**DEFENSE NUCLEAR FACILITIES
SAFETY BOARD**

March 25, 2015

Staff Issue Report

SUBJECT: Aerosol Entrainment Coefficient Based on Testing and Data Analyses for the Waste Treatment and Immobilization Plant

Figure 2. Recommended AEC values in relation to all small- and medium-scale test data analyzed as a function of sparger pressure difference (dP).

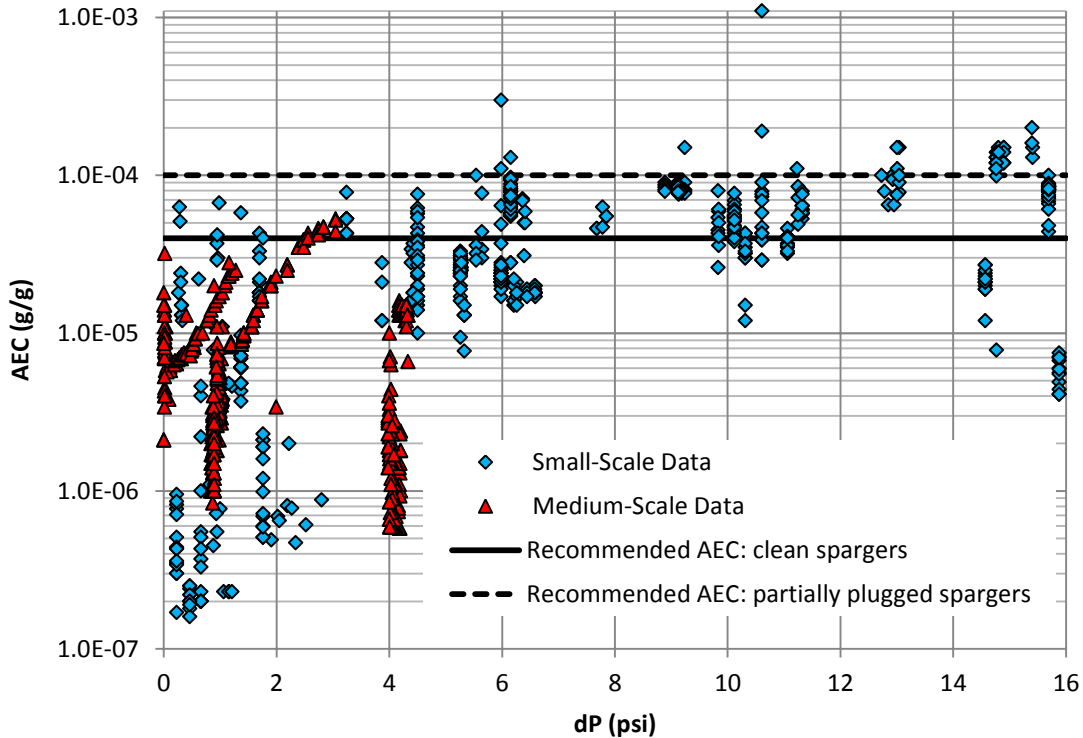
- The largest values of AEC measured in the small-scale tests exceeded 1.0×10^{-3} , and the medium-scale test values exceeded 5.0×10^{-5} . Using arguments regarding enhanced aerosol production and entrainment in the small-scale tests, FAI based the recommended AEC value for WTP on the medium-scale test data. FAI examined the medium-scale test data and concluded plugging of the sparge tubes and gas jetting was also present in some tests and contributed to elevated values of AEC. FAI recommended two bounding values for the AEC:

Figure 2 shows these two recommended values of AEC in relation to all the small- and medium-scale test data [8].

Figure 3. Conceptual model for natural convection in headspace

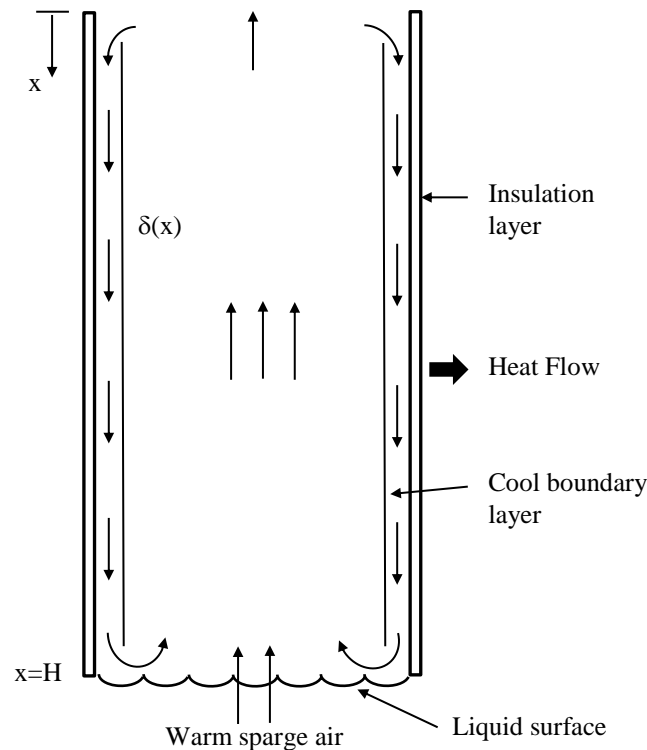
The Board’s staff team examined the FAI report’s model and equations for natural convection in the small-scale tank. The model assumes natural convection in the small-scale tank is driven by a temperature difference between the cooler wall of the vessel and the warmer headspace atmosphere, which results in a downward flow along the wall of the vessel. FAI’s proposed flow pattern within the small-scale tank is given in Figure 3 below. The boundary layer shown in the

figure is the zone of downward flowing cold air adjacent to the tank wall. The natural convection model solves for both the boundary layer thickness and downward flow rate at the wall. The downward flow at the tank wall was converted to an upward velocity in the headspace through an area relationship that neglects the area contained within the boundary layer. The magnitude of the upward velocity due to natural convection was compared with the magnitude of the sparge-induced upward velocity and found to exceed it by about a factor of three. The report concludes that natural convection artificially increased the droplet vertical transport, resulting in artificially high values of AEC.

The analysis presented in the report implicitly assumes that the boundary layer is very thin compared to the diameter of the tank. Specifically, the report estimates the boundary layer thickness along the wall of the tank using an equation for a vertical plate, an approach that is generally valid when the boundary layer thickness is much less than the tank diameter. The Board’s staff team calculated the boundary layer thickness in the small-scale test tank using the equations given in the report and found that the boundary layer grows rapidly to exceed the tank radius. Because the key modeling assumption of a thin boundary layer is not supported by the model results, the conclusion in the FAI report that enhanced entrainment is due to natural convection in the small-scale test tank is not supported by the analysis.

is not defensible. The staff team concludes a more realistic analysis of natural convection utilizing a computational thermal-fluid model would be required to determine the role of natural convection in both test vessels and plant vessels.

Figure 4. Sparger nozzle velocity relative to the critical velocity for jetting for the small-scale test data based on jetting model [8]. Also shown is the pressure drop corresponding to the “jump” in AEC data claimed in the FAI report.

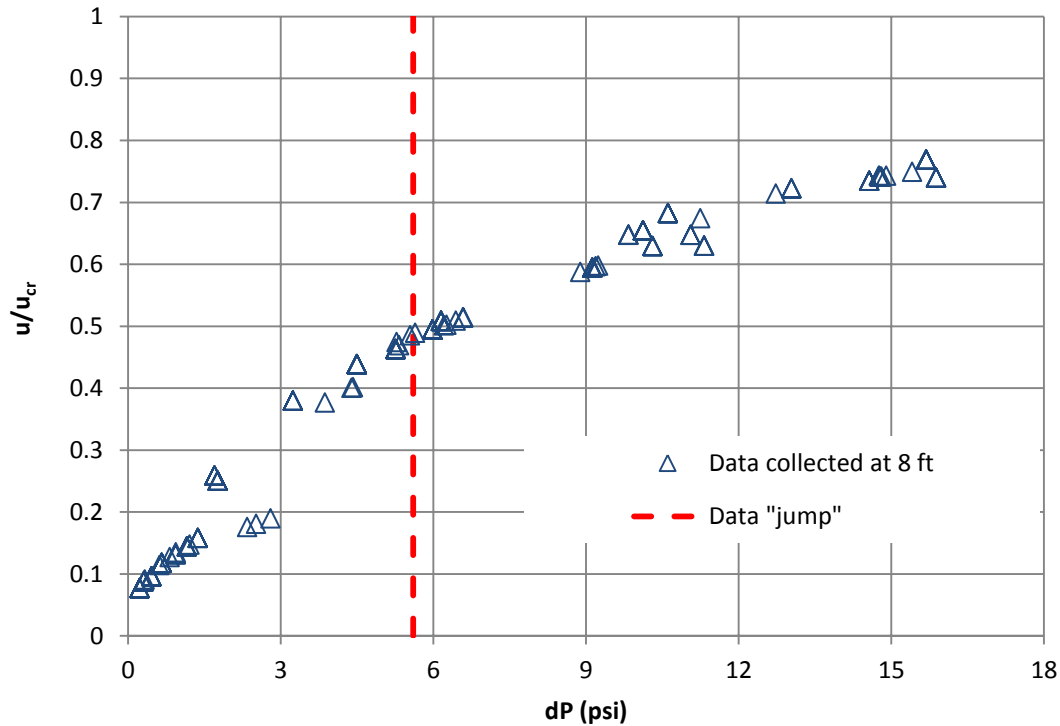
The Board’s staff team independently analyzed whether the data “jump” at 5.6 psi claimed in the report was meaningful and not an artifact of data noise or some other phenomena. The staff team attempted to validate the report’s conclusion by evaluating the data collected at all elevations and found that, while there was some discernable increase in AEC for pressure drops in the range of 5–6 psi, it was a statistically insignificant local feature of the data, and no general trend can be established.

The staff team also found that the pressure drop criterion for sparge jetting presented in the report was conceptually flawed and inconsistent with the model presented in the report. For example, when a plug begins to form, the effective diameter of the sparger orifice is reduced, resulting in an increase in both critical velocity and pressure drop. Using the model equations presented in the FAI report, together with the test data, the staff team calculated the average sparge nozzle velocity and the predicted critical velocity for jetting for all of the small-scale tests. Figure 4 below shows the ratio of these two velocities plotted versus measured pressure drop. The staff team determined that the average nozzle velocity was less than the critical velocity for jetting for all test points. This means that, according to the jetting model presented in the report, when numerically evaluated, the critical pressure drop for jetting was always found to be higher than the measured pressure drop. Therefore, according to the report’s criteria, no jetting was present in any of the tests. Further, the staff team repeated the evaluation for the results of the medium-scale test data and found that, based on the report’s model, sparger jetting was present in all but one test series. This is inconsistent with the report’s claim that only two of the medium-scale test cases exhibited sparger plugging.

Based on these findings, the Board’s staff team concluded that the proposed jetting model does not adequately reflect the data collected. Consequently, this model does not provide an adequate technical justification for asserting that small-scale testing experienced enhanced AECs due to gas jetting. Moreover, the model does not provide an adequate technical justification that the medium-scale data only experienced enhanced AECs due to jetting in two specific cases.
